Access Compliance Report Public Rights-of-Way (Pedestrian Signals)

Main Street: **SENDERO_WAY** Cross Street: **ANTONIO_PKWY** Location: **SE**

ADA ID: **SGRK211116132649** Signal Type: **One Push Button-Non APS** Overall Compliance: **No** Severity Scores: **BTN 1: 35** **BTN 2: N/A** **No BTN: N/A**

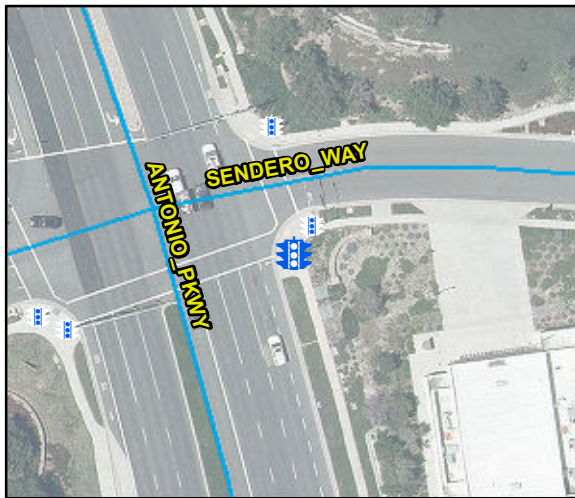
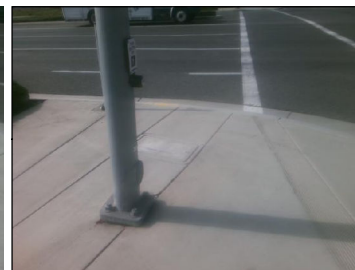
OC Std/PROW: **MUTCD 4e.08, R404.2, R404.3**

Possible Solutions: Replace Signal Push Button With APS Button. Remove & Relocate Sign.
